UNITED STATES PATENT AND TRADEMARK OFFICE

| APPLICATION NO. | FILING DATE | FIRST NAMED INVENTOR | ATTORNEY DOCKET NO. | CONFIRMATION NO. |
|-----------------|-------------|----------------------|---------------------|------------------|
| 10/616,090 | 07/08/2003 | Douglas M. Baney | 10020766-1 | 9657 |

Office Action Summary

Fig. 1

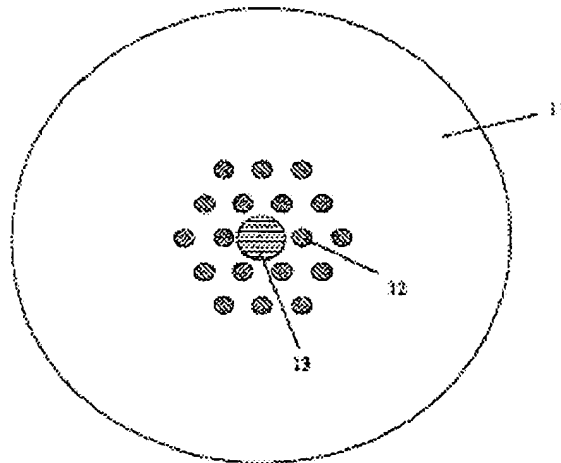
Claim 4: The holey waveguide comprises a core (11); and a plurality of voids formed in said core (12) (See for example Fig. 1).

Fig. 9

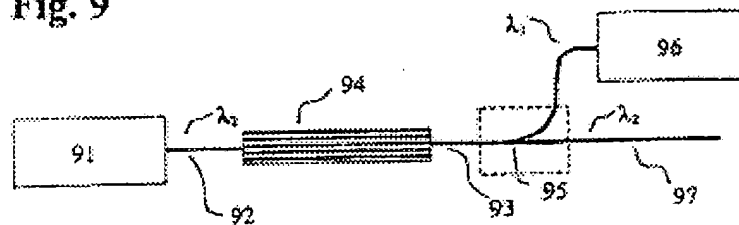
Claim 1: Bjarklev discloses in Figs. 1, 2, 4, 5, and 9 an optical waveguide absorption cell (Fig. 9), comprising: a first wave-guide ((92); a holey waveguide (94) filled with a known selective absorption medium (col. 5, lines 30-36), wherein a first terminus of said holey

waveguide (94) is coupled to a first terminus of said first waveguide; and a second waveguide (93), wherein a first terminus of said second waveguide is coupled to a second terminus of said holey waveguide.

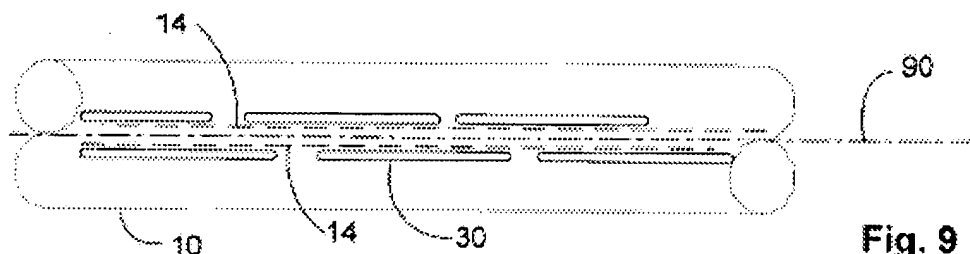
Levenson discloses the method of filling the holey waveguide with the known selective absorption medium through capillary action from the holes in the cladding (Fig. 9 and col. 4, lines 1-6) for the purpose of controlling the refractive index of the waveguide.
